SUBJECT: Forwards addl info re second 10-yr inservice insp summary plan per 840817 request.

Re: Turkey Point Units 3 and 4
Docket Nos. 50-250, 50-251
Inservice Inspection
Second 10-year Summary Program

FIRST & SECOND INTERVAL RELIEF REQUESTS

INSERVICE INSPECTION

FIGURE NO. 1

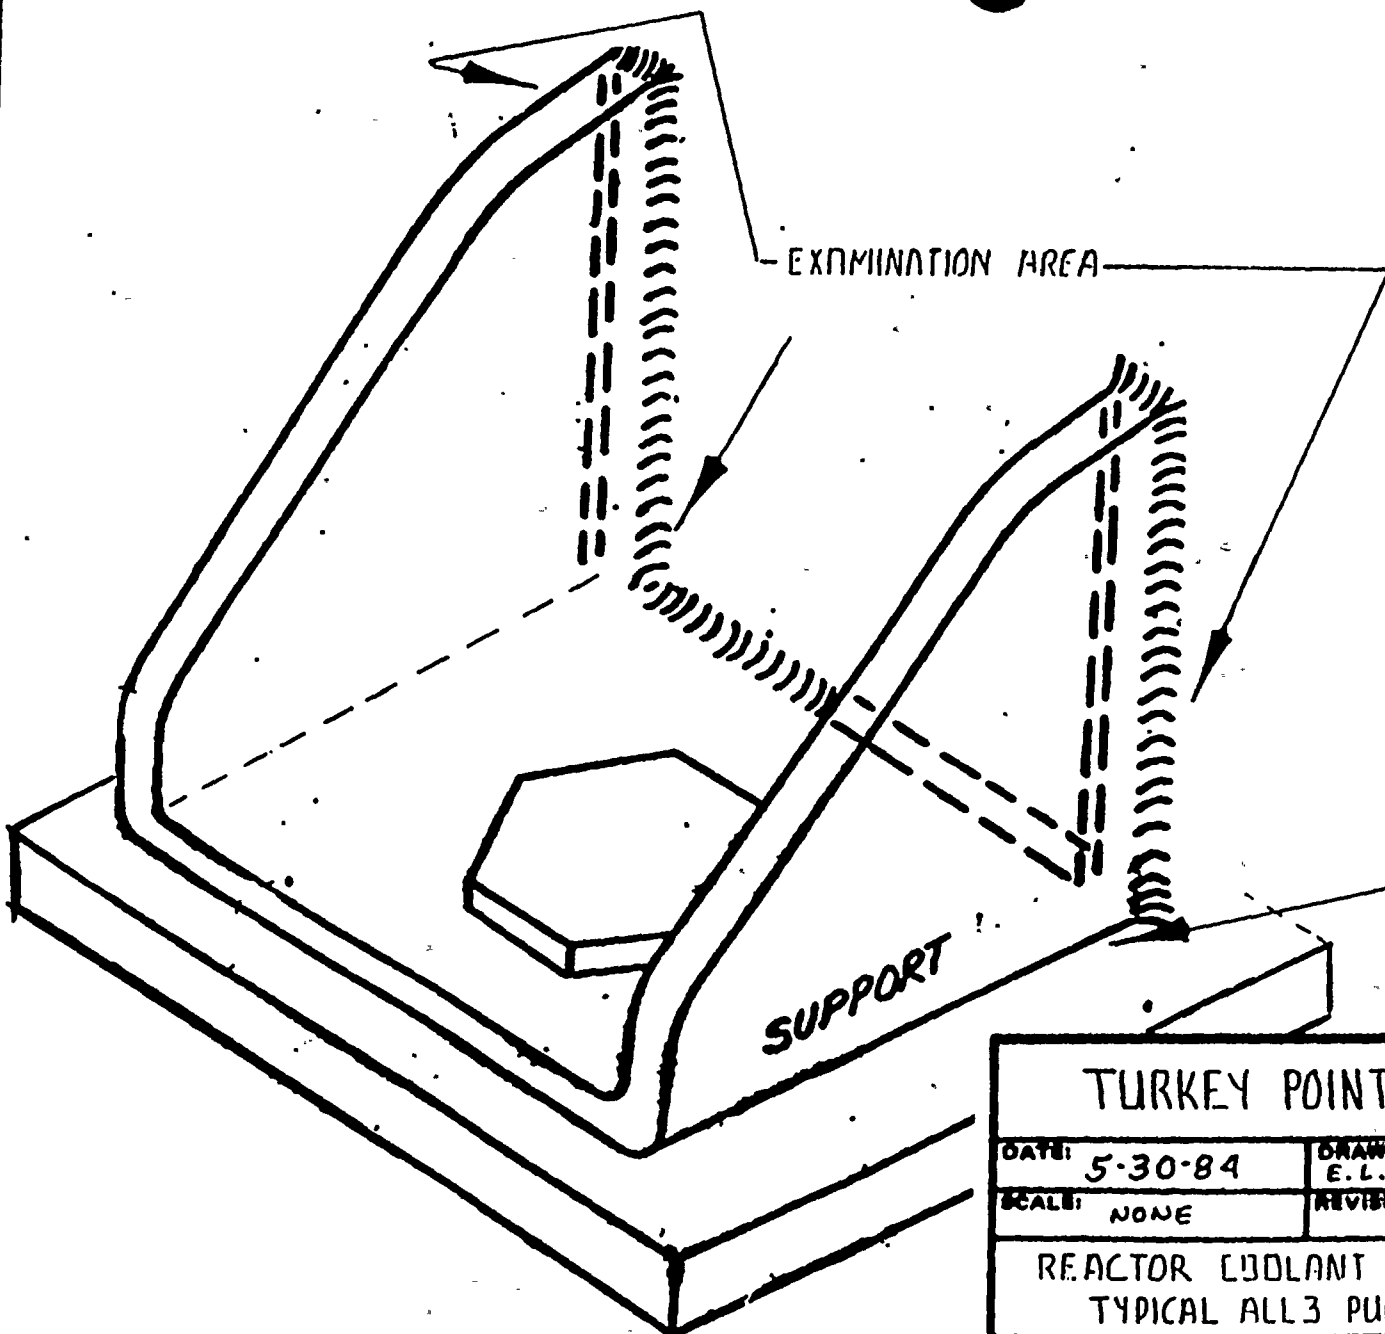
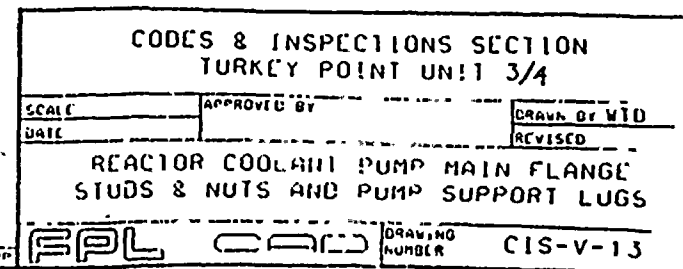
Relief is requested from alternate surface examination of inaccessible weld and adjacent areas of the pump support members not achieved during the Inspection Interval. These include the following welds: Item B5.4

Configuration of the integrally welded supports as welded to the pump body and structural interfaces prohibit 100% surface examination coverage due to inaccessibility of portions of the weld. Figure no. 1 provides a graphic view of what areas of the lug cannot be examined.

- 1) Perform surface examinations per the ISI schedule.
- 2) Upon disassembly of a pump from the pad, conduct a surface examination on the inaccessible area.

FIGURE NO. 1

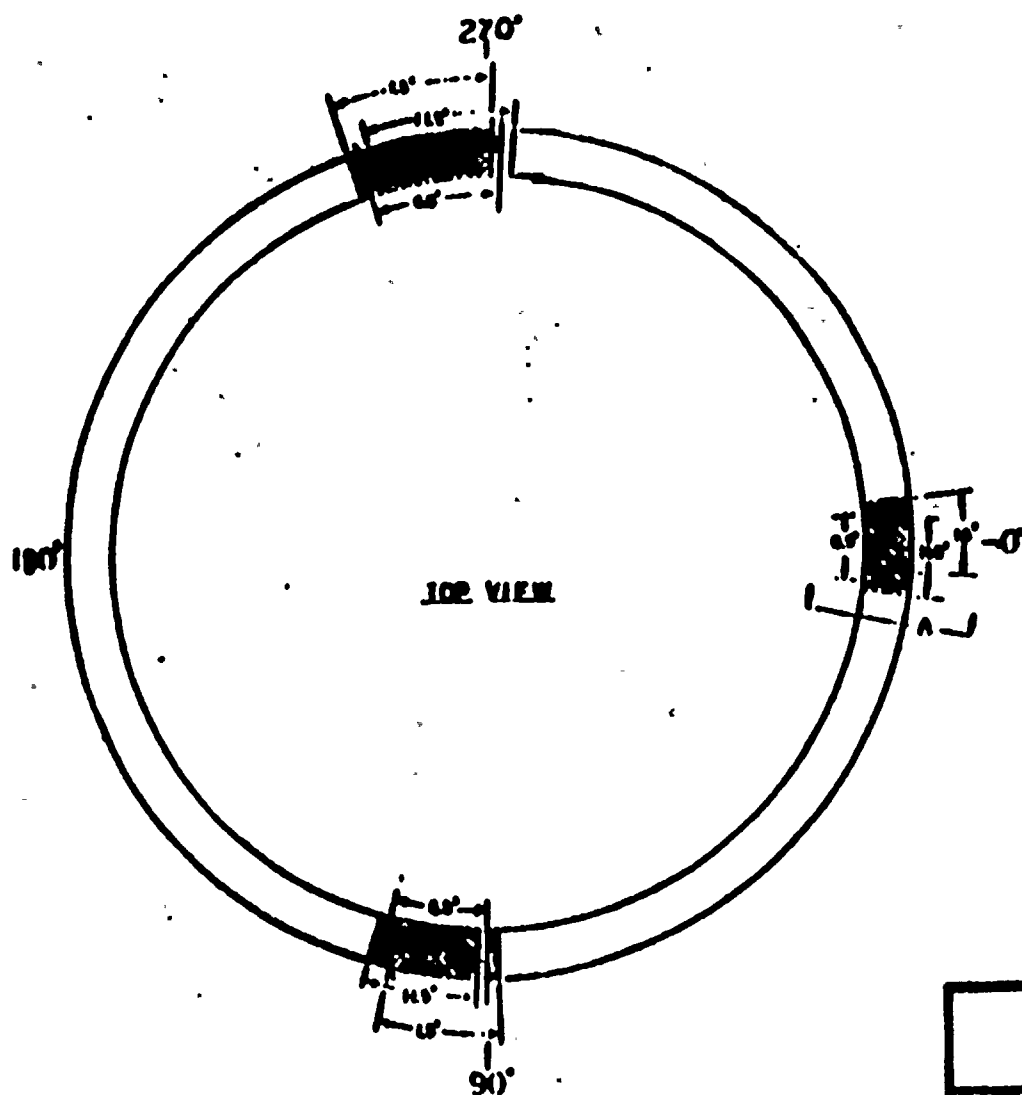
- 1.1 The areas receiving NO COVERAGE DURING THE examination performed from the upper shell side are depicted in Figure no. 2.
- 1.2 Figure no. 3 depicts those areas that did not receive 0 degree, 45 degree transverse or 60 degree transverse weld coverage due to the geometric configuration of the flange radius located just above the weld. Percent of coverage limitation is contained in Table 1.
- 1.3 Examinations performed from the shell side of the weld, essentially provided 100 percent coverage of the weld and 1/2T of base material on the shell side.

DATE: 5-29-84		DRAWN BY: E.L. ANDERSON	APPROVED BY:
SCALE: NONE		REVISED	
LOWER HEAD RING TO DISC WELD			3-WR-9
RELIEF REQUEST NO. 10			FIGURE NO 4

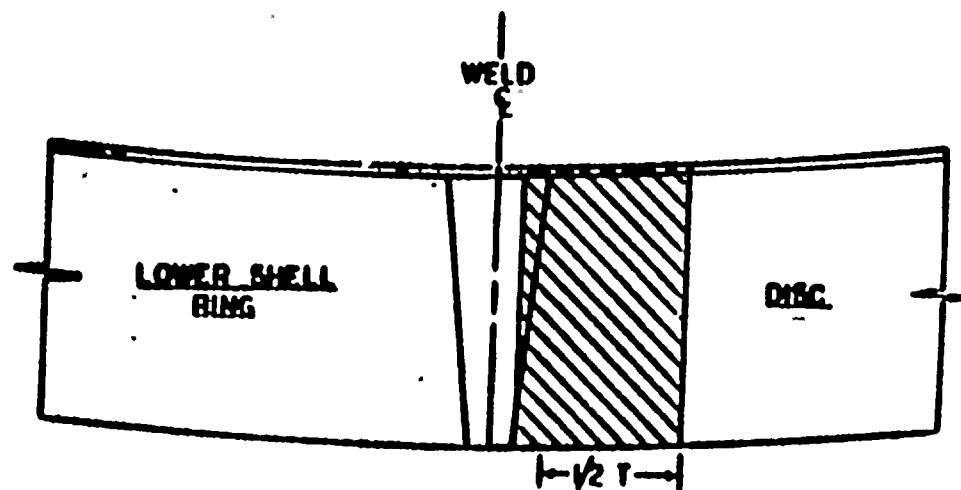
- 2.1 Limitations encountered during the examination of the above welds were attributable to physical limitations imposed by the INCORE INSTRUMENTATION TUBES . This condition was most prominent when performing examinations to detect reflectors oriented parallel to the weld with the search unit positioned on the disc side. Due to the height restrictions and number of tubes in this area, attempts to perform examinations from the Disc side were abandoned. Figure 4 depicts the coverage on the Disc side during scanning from the ring side.

TURKEY POINT UNITS 3.		
DATE: 5-29-84	DRAWN BY: E.L. ANDERSON	APPROVED BY:
SCALE: NONE	REVISED:	
LOWER HEAD RING TO DISC WELD		3-WR-9
RELIEF REQUEST NO 10		DRAWING NUMBER: FIGURE NO. 5

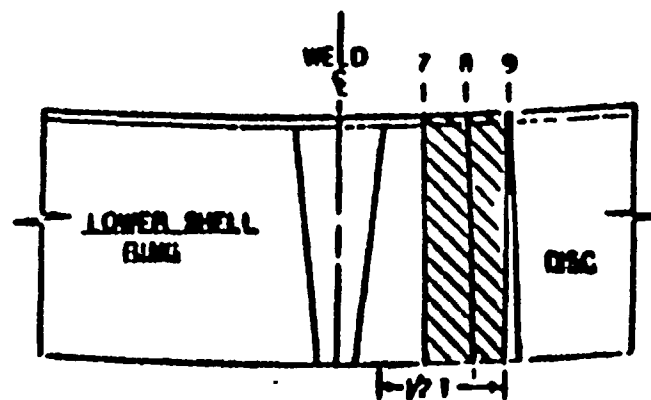
- 2.2 Examinations performed for the purpose of detecting reflector oriented parallel to the examination surface were accomplished utilizing a 0 degree search unit applied to the weld and base material for a distance of 1/2 t. As illustrated in figure 5, a portion of the weld and 1/2t of the base material on the disc side was not examined for the reasons detailed in 2.1 above.

DATE: 5-29-84		DRAWN BY: E. L. ANDERSON	APPROVED BY:
SCALE: NONE		REVISED:	
LOWER HEAD RING TO DISC WELD			3-WR-9
RELIEF REQUEST NO. 10			DRAWING NUMBER FIGURE NO 6

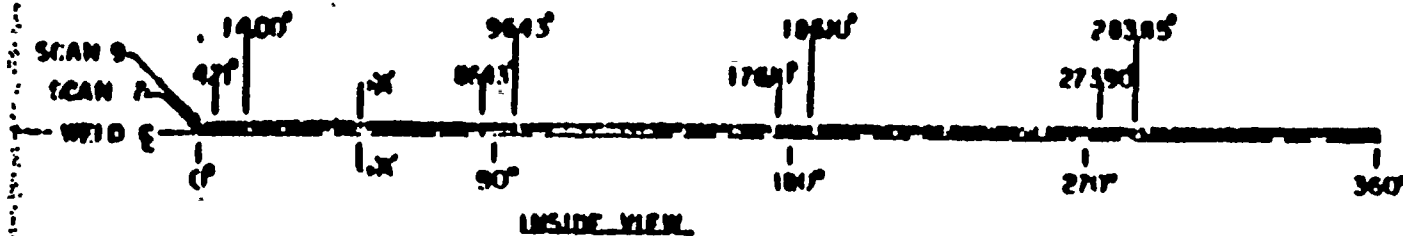
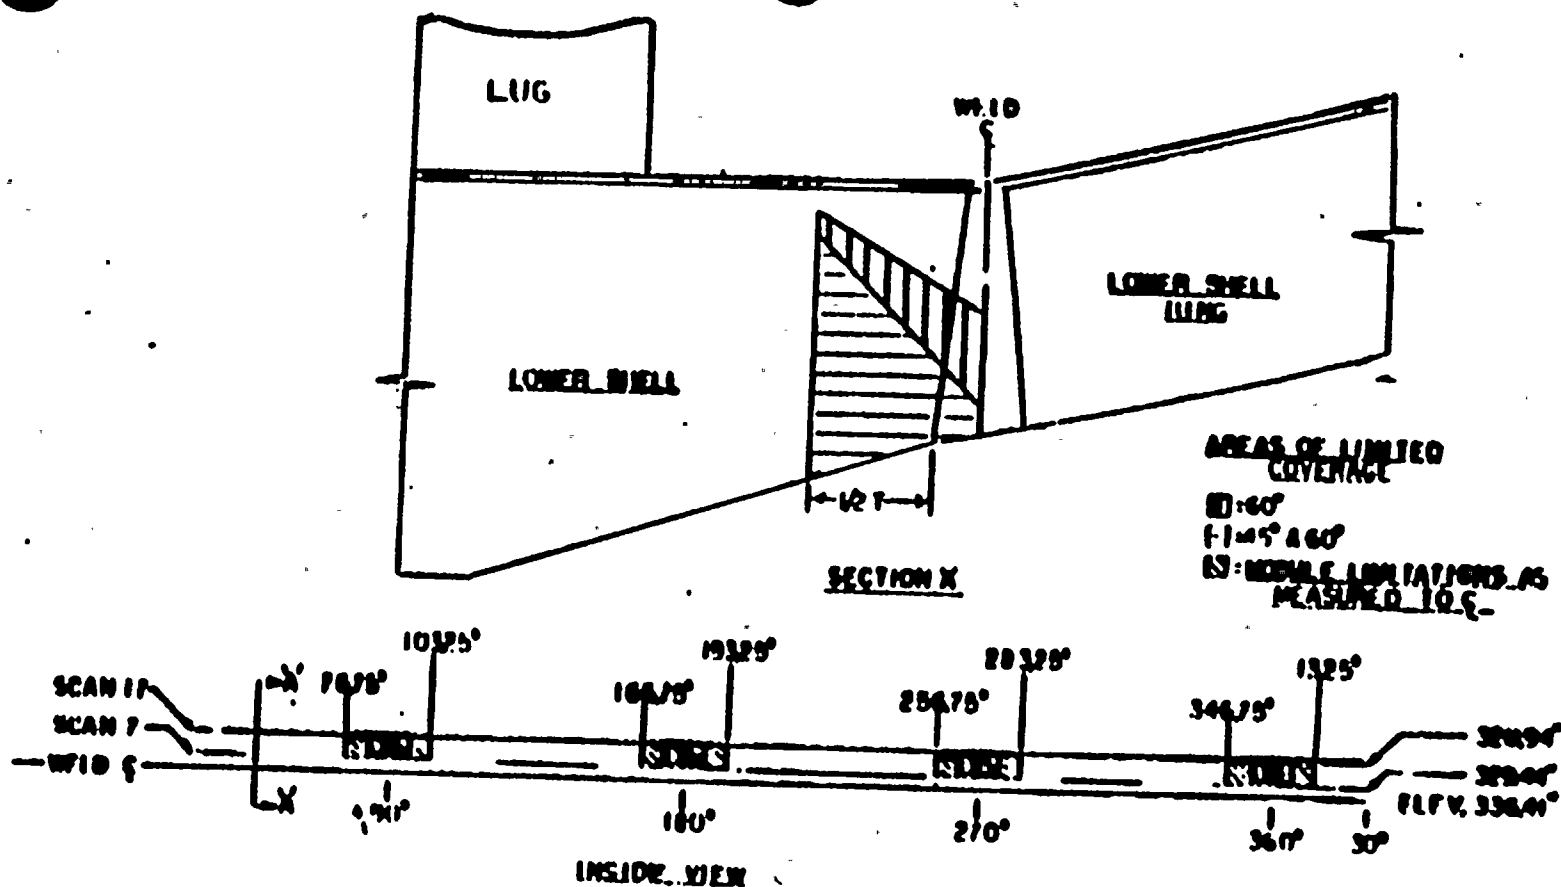
- 2.3 Examinations performed for the purpose of detecting reflectors oriented transverse to the weld were restricted in a portion of the base material on the Disc side of the weld due to the INCORE INSTRUMENTATION TUBES. Figure number 6 identifies the areas where search unit module interference was encountered as a result of the tube interference in four locations around the weld. These limitations were only encountered during scans 8 and 9 of examination no. 2, and scans 7,8, and 9 of examination no. 3, and were limited only to a small portion of the base material on the Disc side.

FIGURE NO. 8

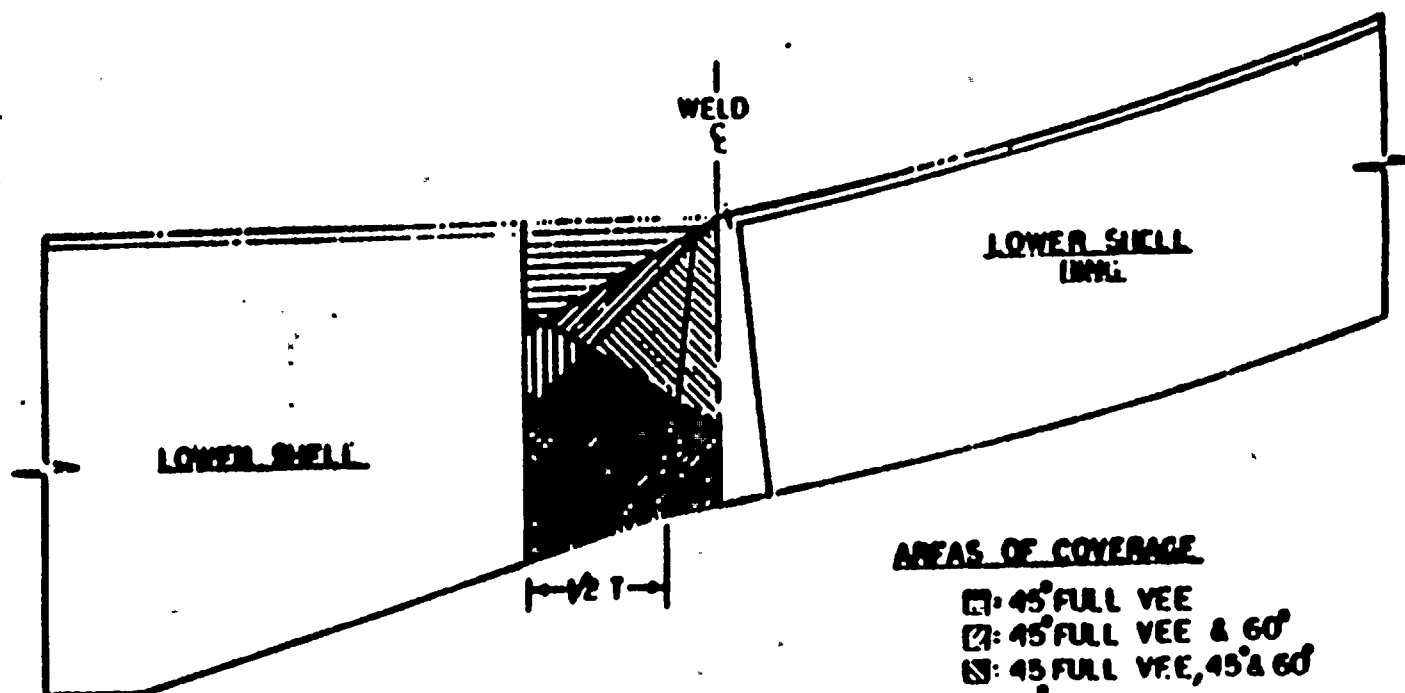
3.2 Figure 8 represents the coverage received in this area when performing examinations from the lower shell ring side. As noted in this figure, the examination area receives coverage with at least one search unit angle and in some cases, two search unit angles.

FIGURE NO. 9

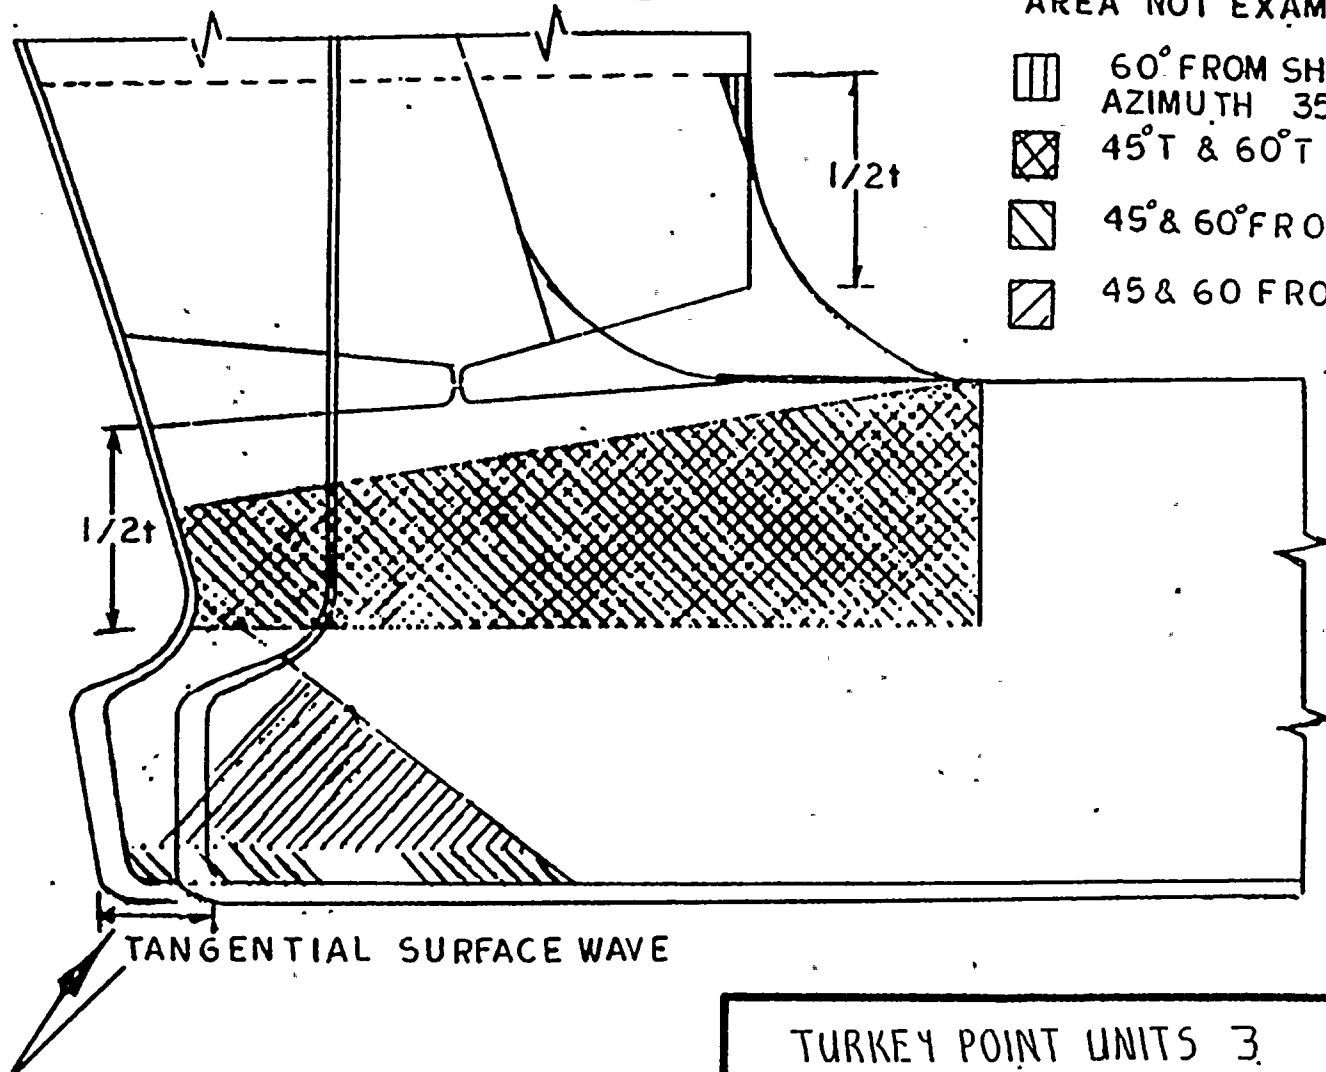
When performing computerized UT examinations of the NOZZLE TO SHELL WELDS from the vessel wall, several areas were described as having limited examination scans. These limitations were restricted to the last several scans of the nozzle to shell examination and were due to the physical limitations imposed by the adjacent nozzles. The limitations all occurred in the vicinity of the 90 or 180 degree nozzle azimuth relative to nozzle orientation. Figure no. 9 depicts those areas not examined and Table no. 3 provides the percent of WELD volume not examined.

TURKEY POINT UNIT NO. 4		
DATE: 5-30-84	DRAWN BY: E.L. ANDERSON	APPROVED BY:
SCALE: NONT.	REVIEWED:	
REACTOR COOLANT SYSTEM WFLD 12" RC-3		
RELIEF REQUEST NO. 13		FIGURE NO. 1

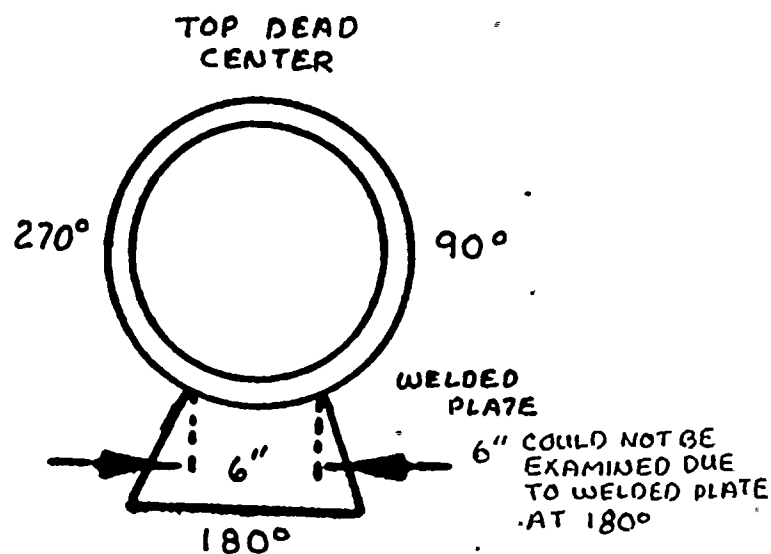
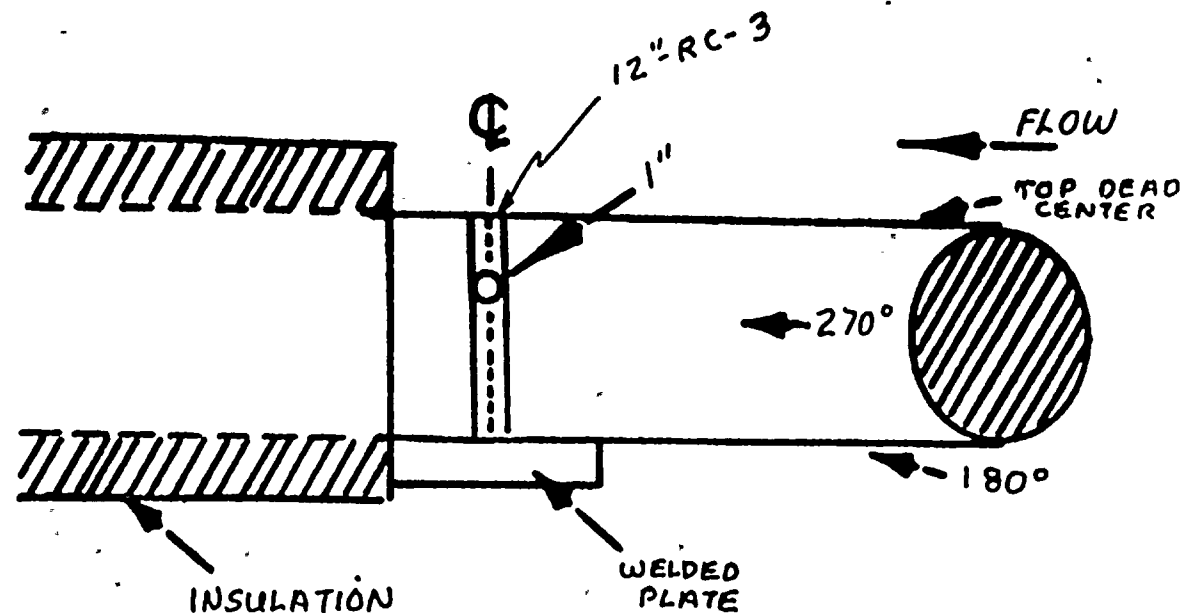
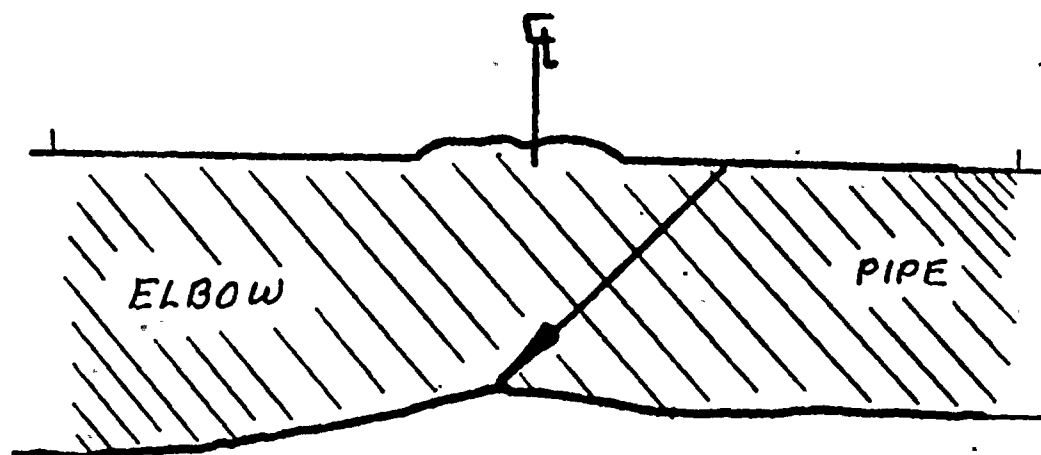
Item B4.5	(12"-RC-3)	6" of circumferential weld	FIG. NO. 1
Item B4.5	(14"-AC-4)	5" of circumferential weld	FIG. NO. 2
Item B4.6	(12"/10"-RC)	An area 4" x 3" of circ. weld	FIG. NO. 3

Fig. no. 1 Limitation due to welded plate at 180 degrees

- 1) Periodic System Leakage tests per category B-P, Table IWB-2500.
- 2) Inservice hydrostatic test per category B-P, Table IWB-2500.
